**Re: Response to REMA Comments  
Slate Upper School  
5100 Outer Ridge Road  
North Haven, Connecticut  
SLR #16156.00003**

SLR International Corporation (SLR) is in receipt of a letter from REMA Ecological Services, LLC, dated January 25, 2021, regarding the above-referenced project. We offer the following responses to the engineering comments contained therein:

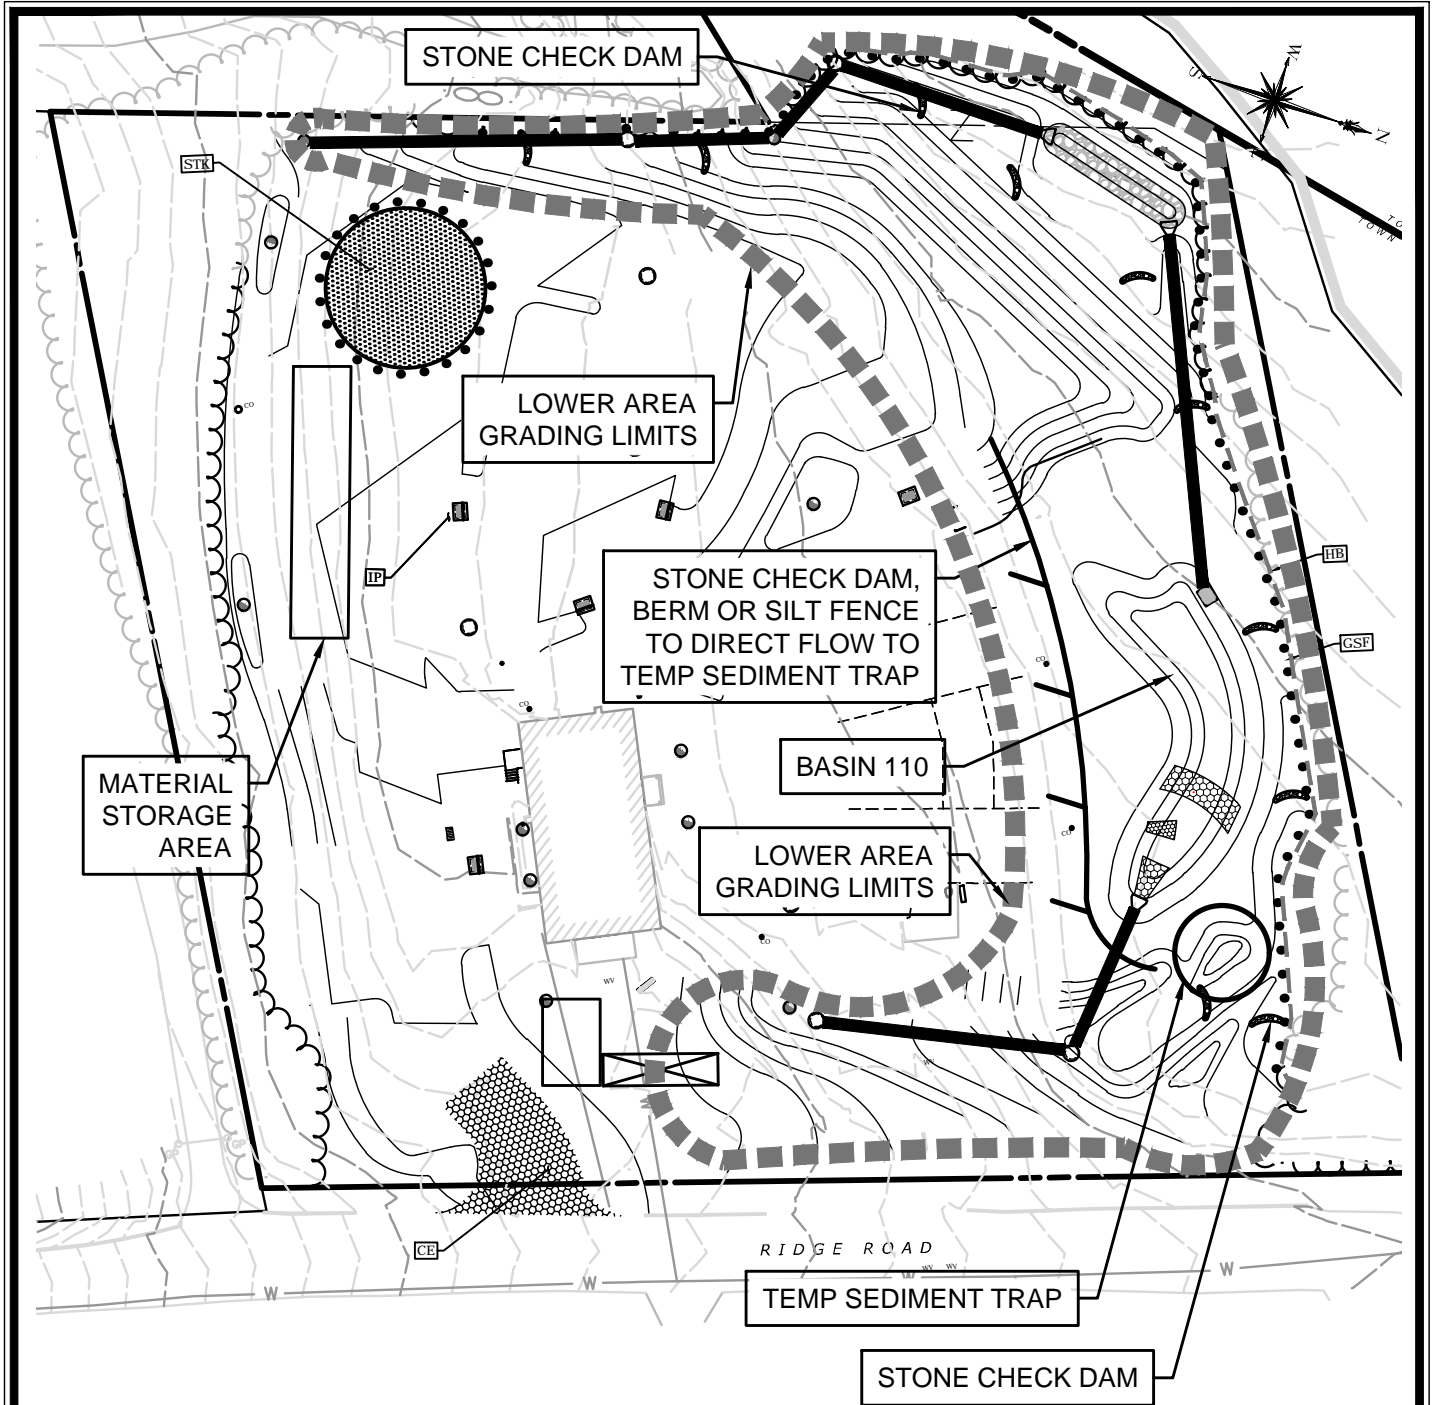
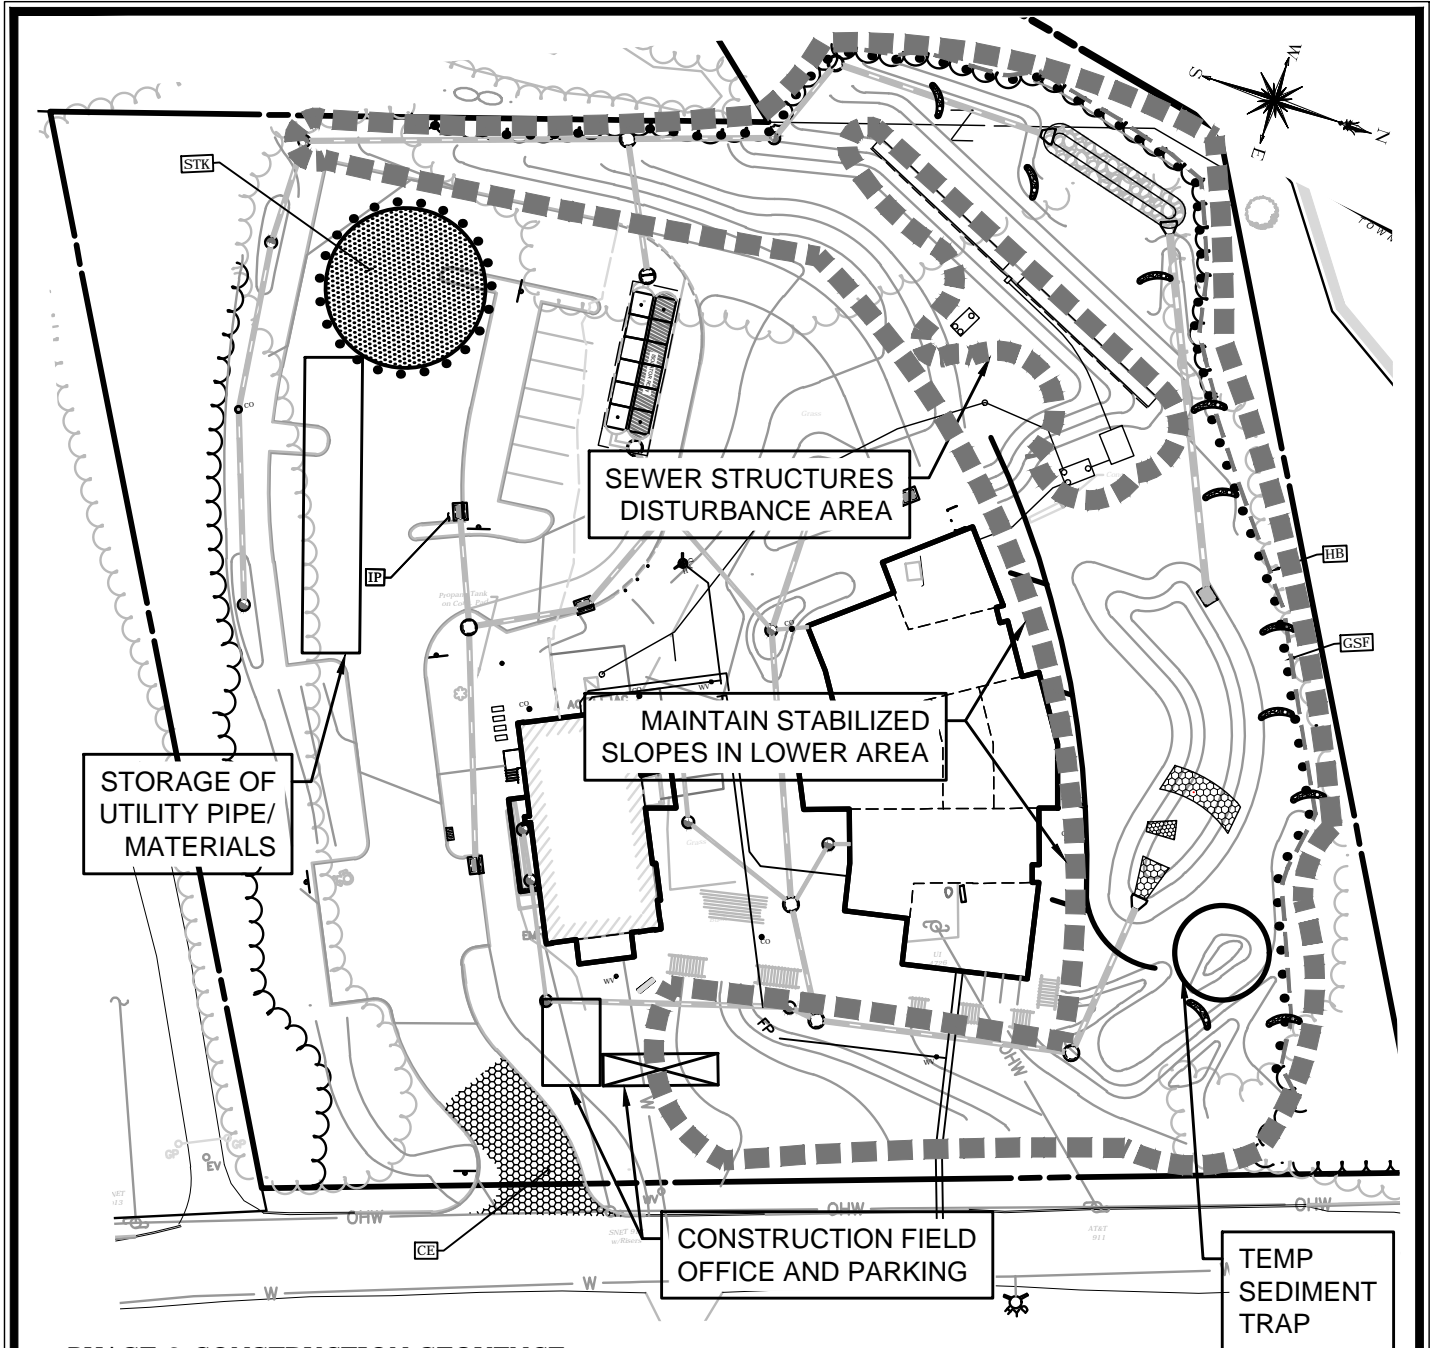
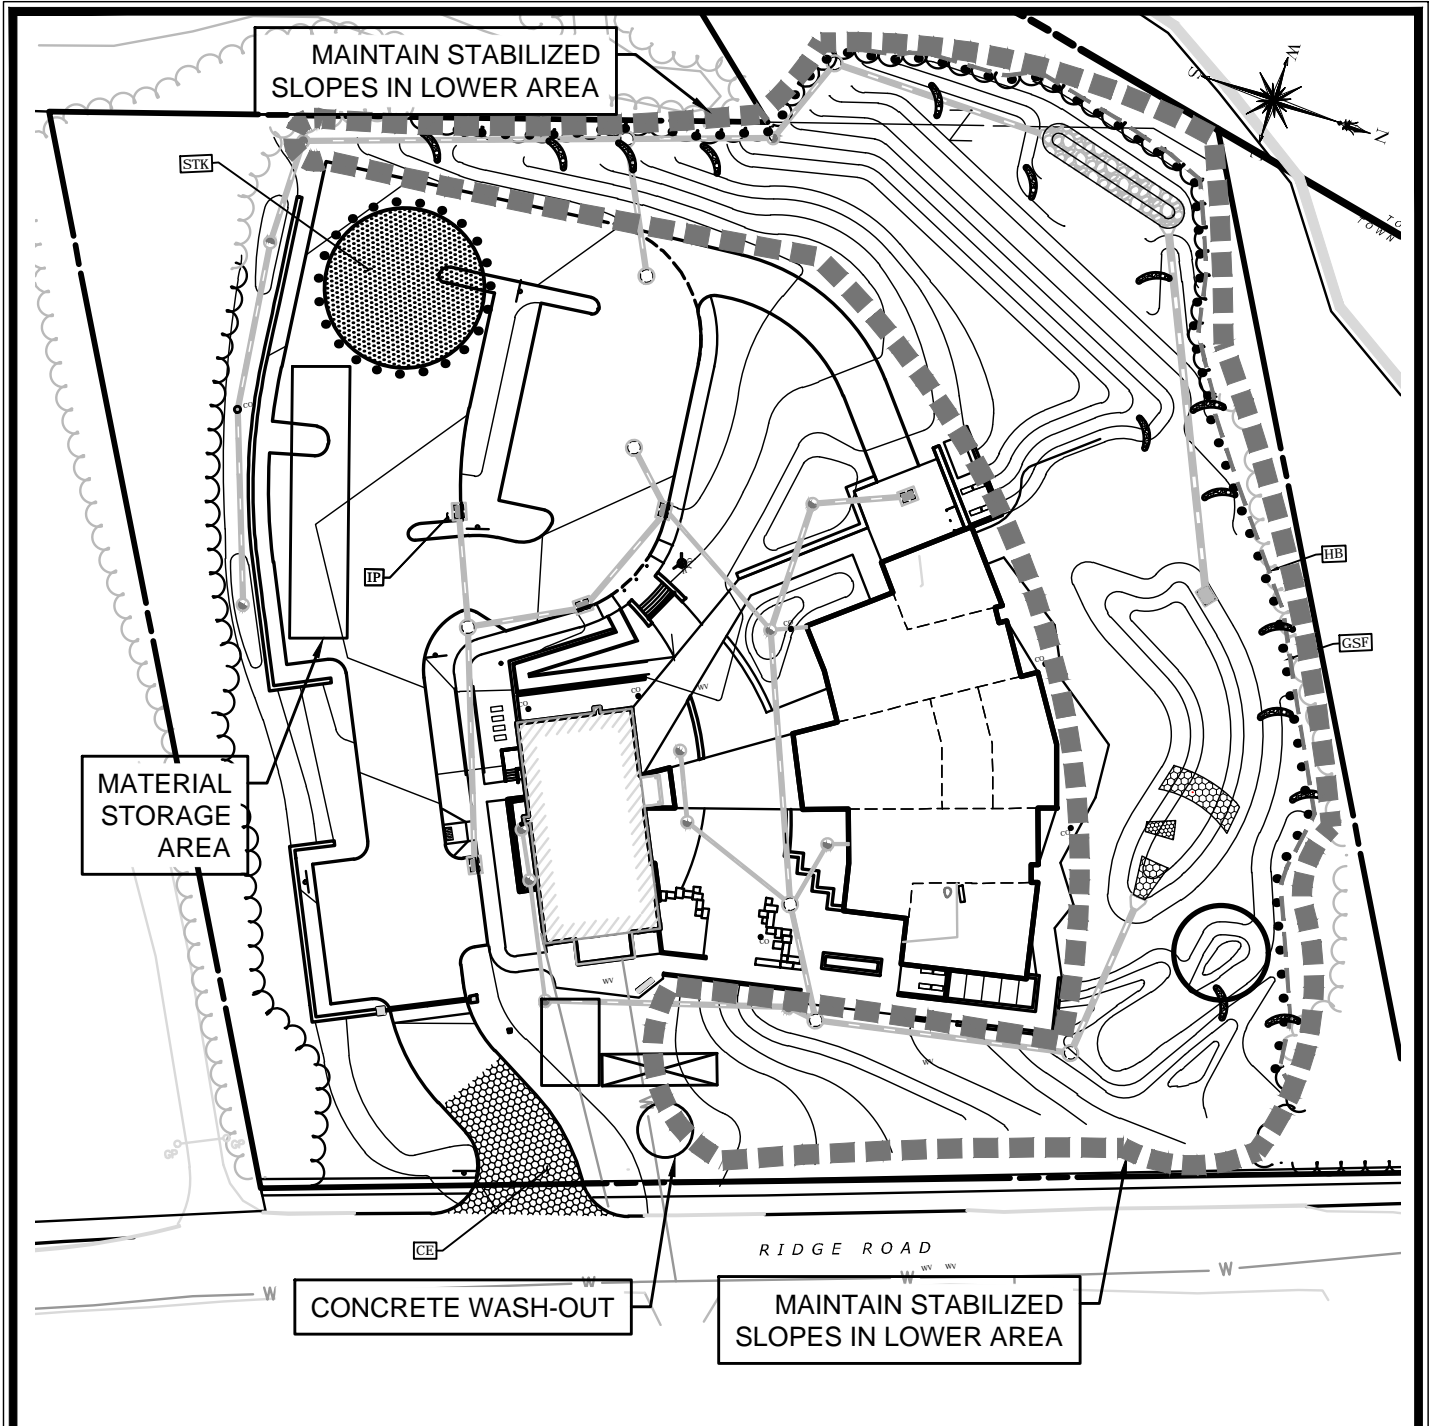
#### **SOIL ERODIBILITY**

All construction activities have been protected with erosion controls. A detailed construction phasing plan and erosion control plan are included with this submission. These plans show that at no time will the entire area be disturbed. The proposed erosion control plan has been designed to mitigate any temporary construction activities. It is our professional opinion that the implementation of the erosion control and phasing plans will prevent any adverse impacts on the adjacent wetlands.

**EXISTING WATERSHED AREA TO WETLANDS**  
**SLATE UPPER SCHOOL**  
 5100 RIDGE ROAD  
 NORTH HAVEN, CONNECTICUT

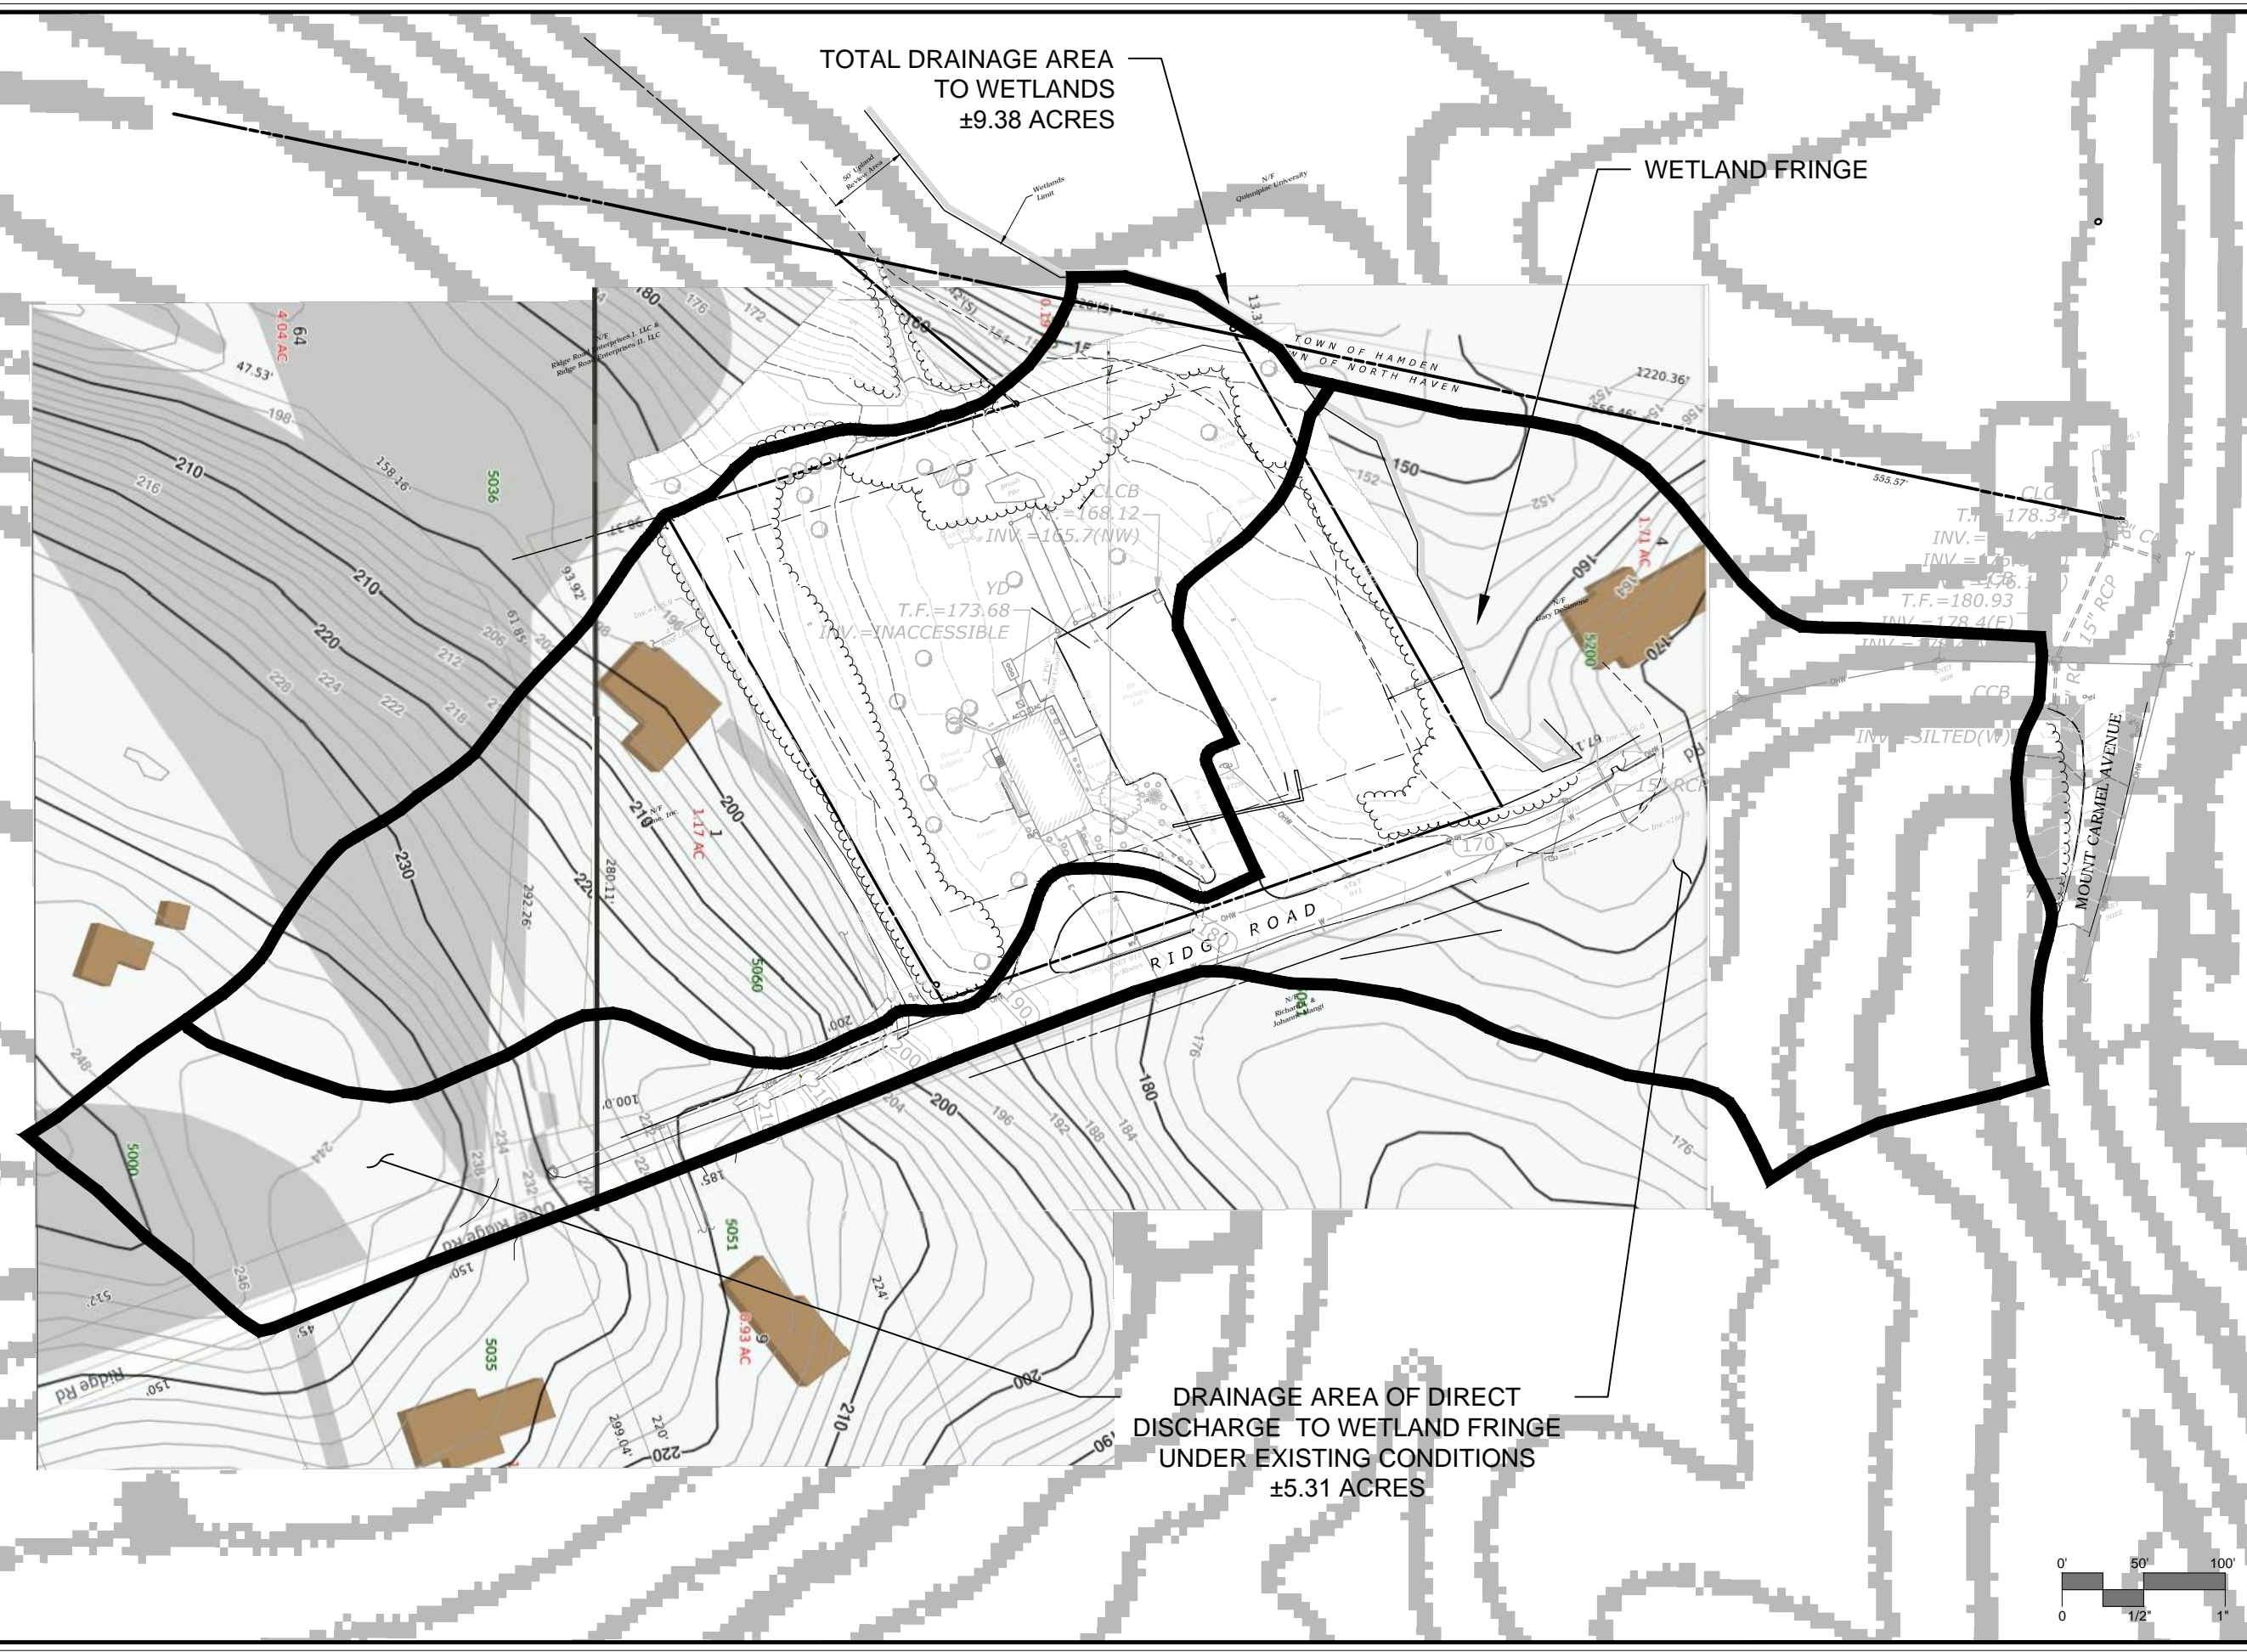
### **IMPACTS TO WETLAND HYDROLOGY**

Under existing conditions, the drainage area of the direct discharge to the aforementioned wetland fringe is 5.31 acres. Under proposed conditions, the direct discharge area to the wetland fringe will be reduced by only 0.62 acres (a reduction of 12% from existing conditions). This reduction in the drainage area will not cause a significant adverse impact to the wetland fringe. It should be noted that the proposed development will not cause a diversion that reduces the drainage area to the downstream wetlands off the property to the west. Illustrative watershed maps for both existing and proposed conditions are attached.
